PROJECT ASSESSMENT REPORT			
<b>Unique Document ID and Revision No:</b>	ONR-SZB-PAR-17-013 Revision 1	<b>TRIM Ref:</b>	2018/55754
<b>Project:</b>	Sizewell B Periodic Shutdown 2017 (Refuelling Outage 15)		
<b>Site:</b>	Sizewell B		
<b>Title:</b>	EDF Energy Nuclear Generation Limited (NGL) – Sizewell B – Consent under Licence Condition 30(3) to start-up the reactor following periodic shutdown.		
<b>Licence Instrument No:</b> (if applicable)	LI 553		
<b>Nuclear Site Licence No:</b>	63		
<b>Licence Condition:</b>	30(3)

**Sizewell B – Periodic Shutdown 2017 (Refuelling Outage 15)**

**EDF Energy Nuclear Generation Limited (NGL) – Sizewell B - Consent under Licence  
Condition 30(3) to start-up the reactor following periodic shutdown.**

Project Assessment Report ONR-SZB-PAR-17-013  
Revision 1  
January 2018

**Figure 1 - Steam Generator Drain Region Layout and Welds**

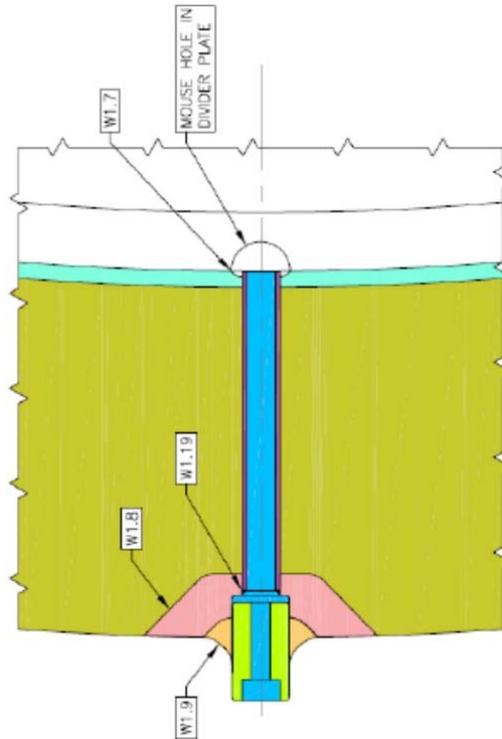
81. The drain is comprised of a small penetration (approximately 18mm diameter) through the channel head shell and cladding into which a small bore tube 'insert' is inserted. The tube insert is adjacent and above a short nozzle 'boss' that partially extends beyond the external surface of the channel head forging. The configuration of the drain penetration is shown in Figure 1.
